'The "Golden Points" and nonequilibrium correction of high-accuracy frost point hygrometers' by Poltera et al.

Author response to reviewer comments

'Comment on egusphere-2025-2003', Anonymous Referee #1, 01 Jul 2025

Modern-Era Retrospective Analysis for Research and Applications, Version 2 (MERRA-2)
50 hPa Abs Potential Vorticity [PVU], Heights [dam]

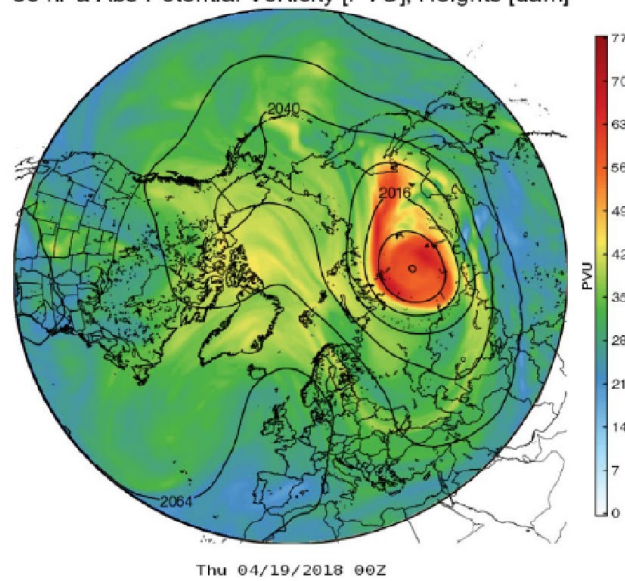
- Section 5.5.1, in particular, the part “High humidity and low number density of aerosol particles point to the polar vortex as a possible region of origin.”: Just out of curiosity, I looked at a reanalysis data set MERRA-2 (<https://gmao.gsfc.nasa.gov/reanalysis/MERRA-2/docs/>) whether this could be a case. NASA/GMAO has a website, <https://fluid.nccs.nasa.gov/reanalysis/>, where we can quickly see weather charts, for example, of potential vorticity at 50 hPa over the Arctic region: https://fluid.nccs.nasa.gov/reanalysis/classic_merra2/?stream=MERRA2&field=epv&level=50&fcst=20180419®ion=nps&tau=00&track=none

The above figure shows that air mass with relatively high PV values (maybe in the form of differential advection) was actually coming to the western Europe region. The maximum PV stream (colored in yellow) over Europe is located somewhat to the east, but this may be related to difference in time (00 UTC for this figure), actual balloon trajectory, the choice of 50 hPa, etc. More investigation would be needed by downloading and analyzing full model-level reanalysis data (e.g., MERRA-2, ERA5, etc.) to investigate whether the hypothesis is true, although I am not suggesting to do so for this paper manuscript.

We thank the reviewer for this analysis of the MERRA-2 reanalysis data set. We have performed a similar analysis, but decided not to include it in the paper.
